Informal document **GRSP-54-15**
(54th GRSP, 17-20 December 2013
agenda item 18(b))

**Consolidated version of the UN Regulation No. 127 including
Corr. 1 to the original version, draft Supplement 1 to the original
version and the draft 01 series of amendments to the UN
Regulation.**

The consolidated text reproduced below was prepared by the expert from the International Organization of Motor Vehicle Manufacturers (OICA) to align the test requirements of UN Regulation No. 127 to UN GTR No. 9 Phase 2 (Flex-PLI) and Amendment 2 to the UN GTR (determination of the headform test points). It is based on ECE/TRANS/WP.29/GRSP/2013/26 and GRSP-54-09. The modifications to the current text of UN GTR No. 9 are marked in bold for new or strikethrough for deleted characters. Moreover the text of **GRSP-54-09 (draft Supplement 1 to the original version of the UN Regulation)** is marked in red and the text of **ECE/TRANS/WP.29/GRSP/2013/26 (draft 01 series of amendments)** is marked in green.

Figure 1
 Flexible lower legform impactor
 Dimensions and centre of gravity locations of femur, knee joint and tibia (Side view)

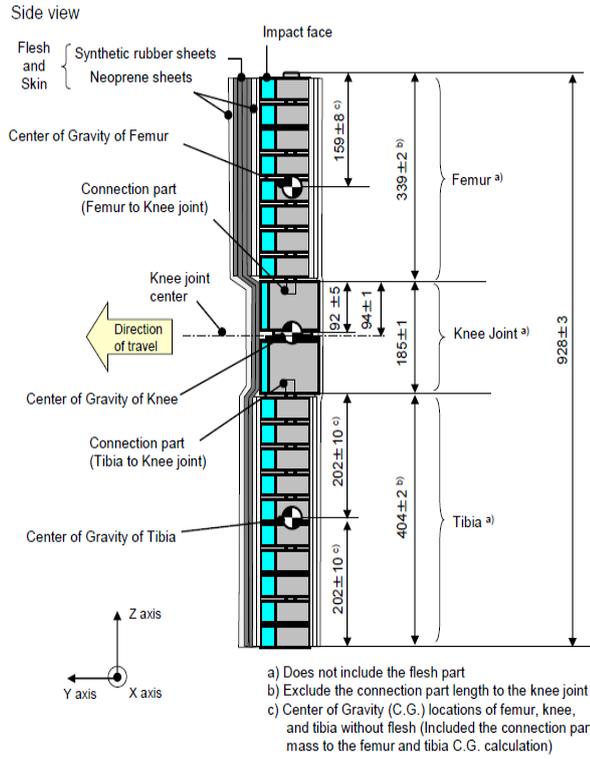
The flexible lower legform impactor shall consist of flesh and skin, flexible long bone segments (representing femur and tibia), and a knee joint as shown in Figure 1. The assembled impactor shall have a total mass of $13.2 \pm [0.7]$ kg. The dimensions of the fully assembled impactor shall be as defined in Figure 1.

Brackets, pulleys, **protectors, connection parts**, etc. attached to the impactor for the purposes of launching ~~† [and][or] protection~~; may extend **beyond** the dimensions **and tolerances** shown in Figure 1 **and Figures 2 (a) and (b)**.

Figure 3
 Flexible lower legform impactor instrument locations

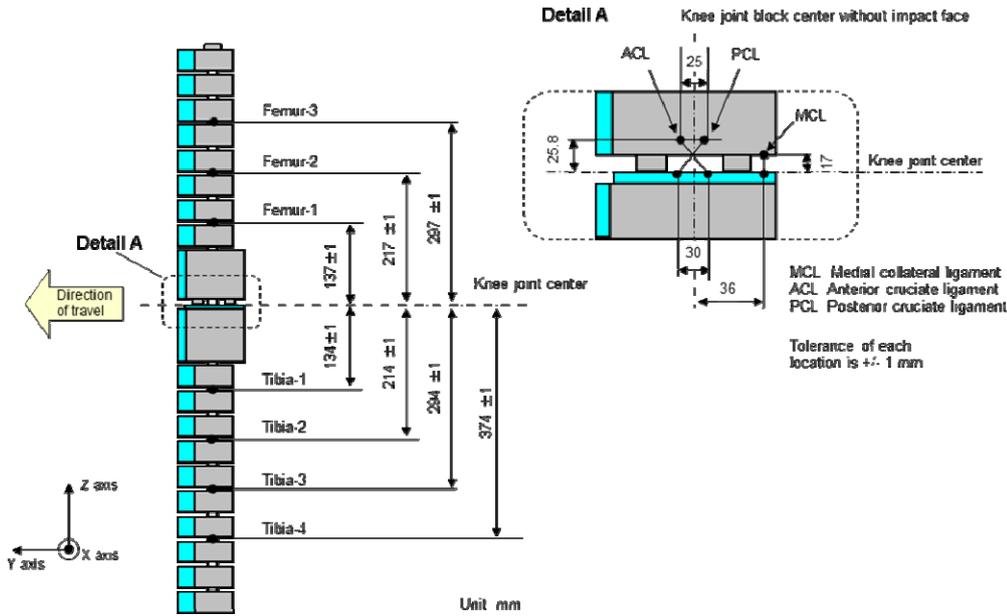
2. Lower legform instrumentation
 - 2.1. ~~An uniaxial accelerometer shall be mounted on the non-impacted side of the tibia, 66 ± 5 mm below the knee joint centre, with its sensitive axis in the direction of impact.~~ Four transducers shall be installed in the tibia to measure bending moments at the locations within the tibia. Three transducers shall be installed in the femur to measure bending moments applied to the femur. The sensing locations of each of the transducers are as defined in Figure 2. The measurement axis of each transducer shall be the X-axis of the impactor.

Figure 1
 Flexible lower legform impactor: Flesh and skin dimensions

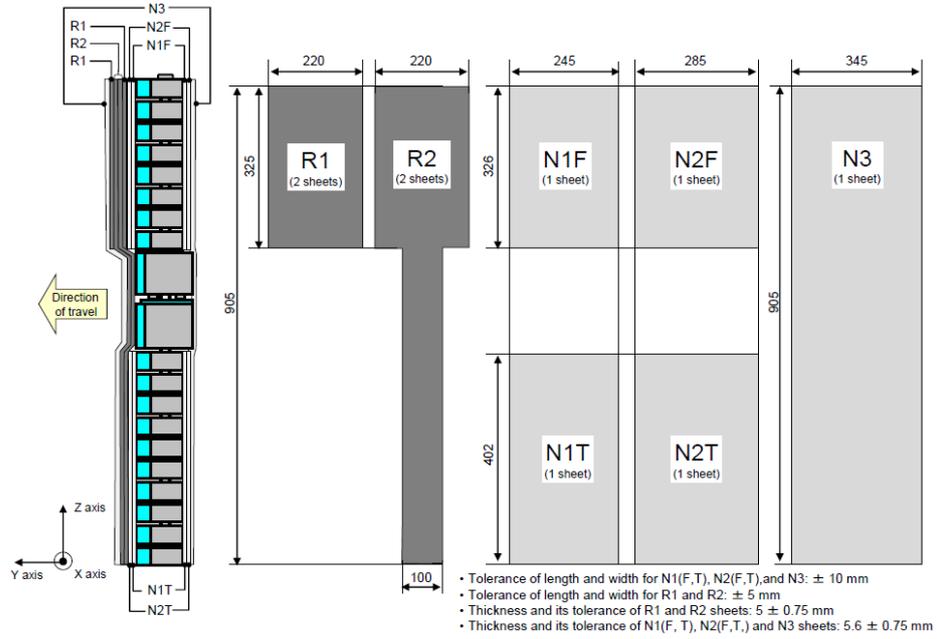
1. **Flexible Lower legform impactor**
- 1.1. ~~For each test the impactor shall be fitted with new foam flesh cut from one of up to four consecutive sheets of foam type CF 45 flesh material or equivalent, produced from the same batch of manufacture (cut from one block or "bun" of foam), provided that foam from one of these sheets was used in the dynamic certification test and the individual weights of these sheets are within ± 2 per cent of the weight of the sheet used in the certification test.~~ **(femur, knee joint and tibia) shall be covered by flesh and skin composed of synthetic rubber sheets (R1, R2) and neoprene sheets (N1F, N2F, N1T, N2T, N3) as shown in Figure 1. The size of the sheets shall be within the requirements described in Figure 1. The sheets are required to have compression characteristics as shown in Figure 2. The compression characteristics shall be checked using material from the same batch as the sheets used for the impactor flesh and skin.**

Figure 24
Flexible Lower legform impactor to bumper tests for complete vehicle in normal ride attitude (left) and for cut-body mounted on supports (right)

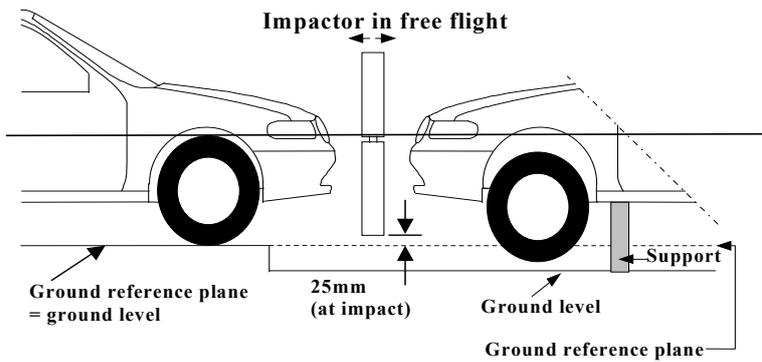
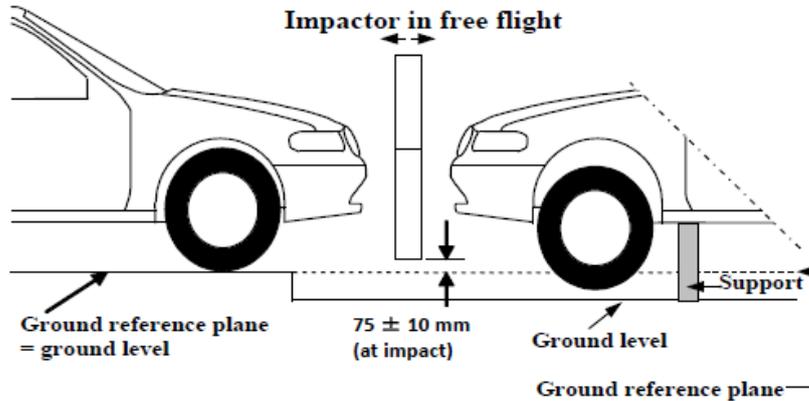
- 1.7. The bottom of the impactor **(without parts needed for the purposes of launching and/or protection)** shall be at 25 ± 75 mm above ground reference plane at the time of first contact with the bumper (see Figure 24), with a ± 10 mm tolerance. When setting the height of the propulsion system, an

Figure 1
Flexible lower legform impactor: Requirement corridors of the femur and the tibia in the static certification test (see paragraph 1.2.2. of this Annex)

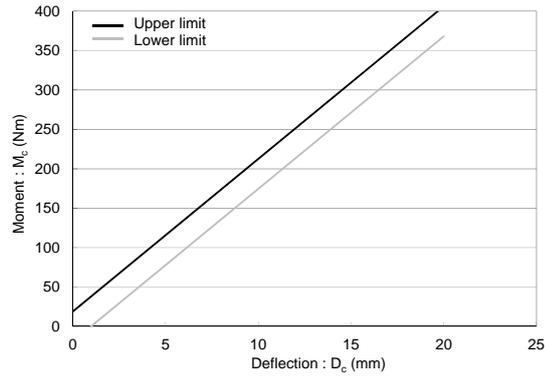
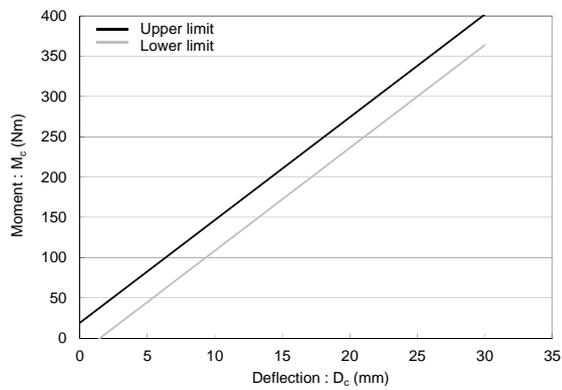
- ~~frequency noise without significantly affecting the measurement of the response of the impactor.~~
- 1.2.2. **When the femur and the tibia of the impactor are loaded in bending in accordance with paragraph 1.2.4., the applied moment and the generated deflection at the centre of the femur and the tibia (M_c and D_c) shall be within the corridors shown in Figure 1.**

Figure 2
Flexible lower legform impactor: Requirement corridors for the knee joint in the static certification test (see paragraph 1.2.3. of this Annex)

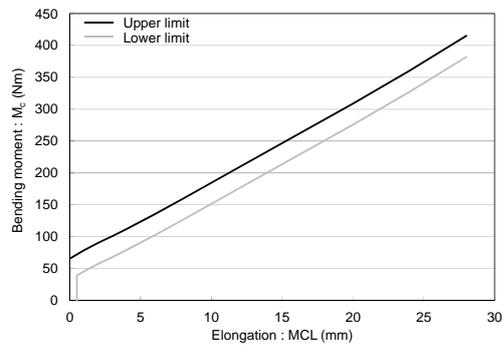
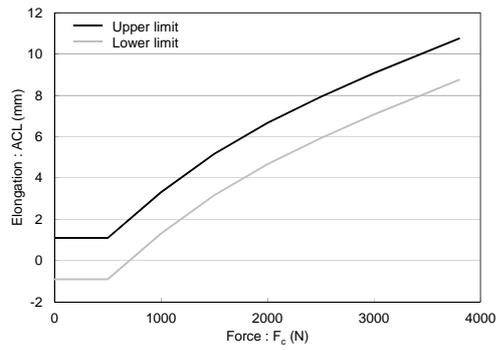
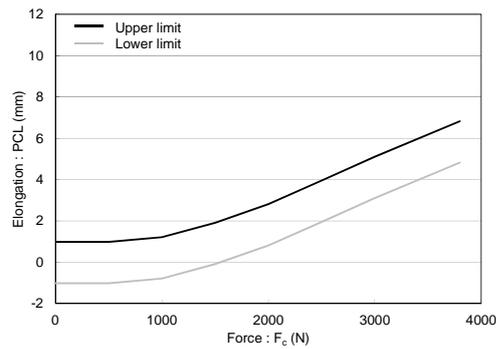
- 1.2.3. **When the knee joint of the impactor is loaded in bending in accordance with paragraph 1.2.5 of this Annex, the MCL, ACL, and PCL elongations and applied bending moment or the force at the centre of the knee joint (M_c or F_c) shall be within the corridors shown in Figure 2.**

Figure 5
 Flexible lower legform impactor: Test set-up for the knee joint in the static certification test (see paragraph 1.2.5.)

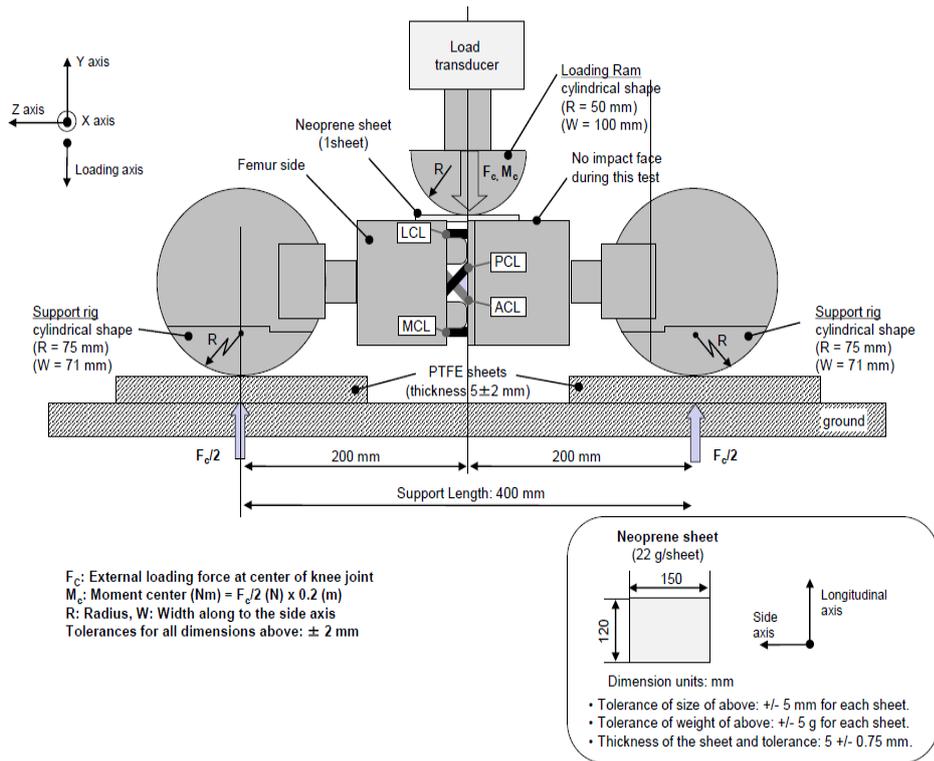
- 1.2.5. **The ends of the knee joint shall be mounted to the support rig firmly as shown in Figure 5. The Y-axis of the impactor shall be parallel to the loading axis within $\pm 2^\circ$ tolerance. To obtain repeatable loading, low friction Polytetrafluoroethylene (PTFE) plastic pads are used under each support (see Figure 5). To avoid impactor damage, a neoprene sheet**

The centre of the loading force shall be applied at the knee joint center within ± 2 mm tolerance along the Z-axis (see Figure 5). The external load shall be increased so as to maintain a deflection rate between 10 and 100 mm/minute until the bending moment at the centre part of the knee joint (M_c) reaches 400 Nm.

Figure 6
 Flexible lower legform impactor: Test set-up for the dynamic lower legform impactor certification test (pendulum test, see paragraph 1.3.3.1.)

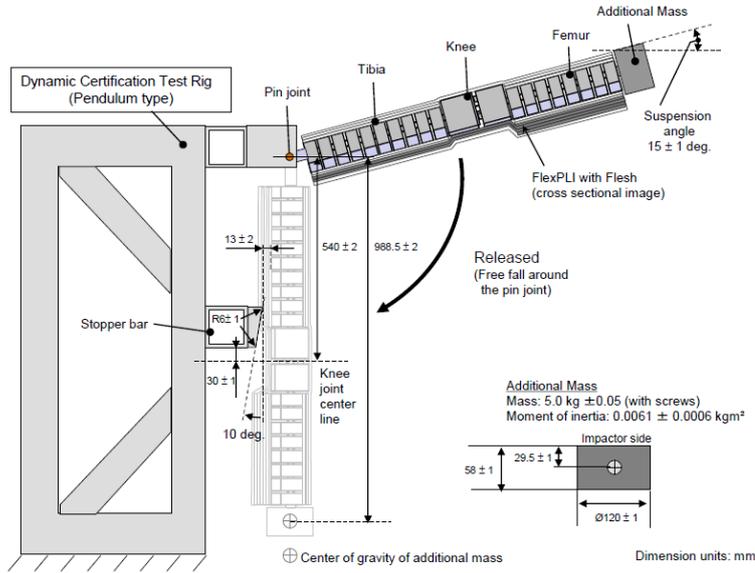
1.3.3.1. The flexible lower legform impactor, including the flesh and skin, shall be suspended from the dynamic certification test rig $15 \pm 1^\circ$ upward from the horizontal as shown in Figure 6. The impactor shall be released from the suspended position and fall freely against the pin joint of the test rig as shown in Figure 6.

and skin shall be located 13 ± 2 mm from the front upper edge of the stopper bar when the impactor is hanging freely as shown in Figure 6.

Figure 7
 Flexible lower legform impactor: Test set-up for the dynamic lower legform impactor certification test (inverse test, see paragraph 8.1.3.4.)

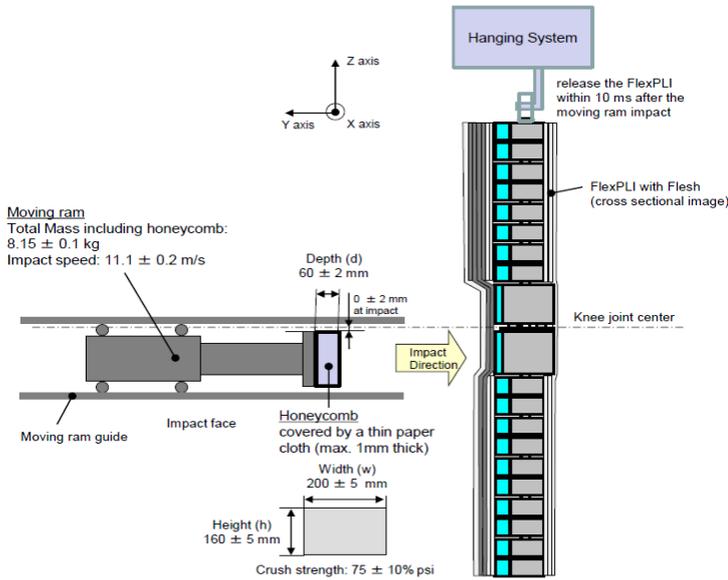
1.4.3.1. The assembled flexible lower legform impactor (with the flesh and skin) shall be hung vertically and freely suspended from a test rig as shown in Figure 7. It is then impacted by the upper edge of a linearly guided aluminium honeycomb impactor, covered by a thin paper cloth with a maximum thickness of 1 mm, at an impact speed of 11.1 ± 0.2 m/s. The legform shall achieve a free flight condition within 10 ms after the time of first contact of the honeycomb impactor.

1.4.3.4. At the time of the first contact, the flexible lower legform impactor pitch angle (rotation around the Y-axis) and therefore the pitch angle of the velocity vector of the honeycomb impactor shall be within a tolerance of $\pm 2^\circ$ in relation to the lateral vertical plane. The flexible lower legform impactor roll angle (rotation around the X-axis) and therefore the roll angle of the honeycomb impactor shall be within a tolerance of $\pm 2^\circ$ in relation to the longitudinal vertical plane. The flexible lower legform impactor yaw angle (rotation around the Z-axis) and therefore the yaw angle of the velocity vector of the honeycomb impactor shall be within a tolerance of $\pm 2^\circ$.
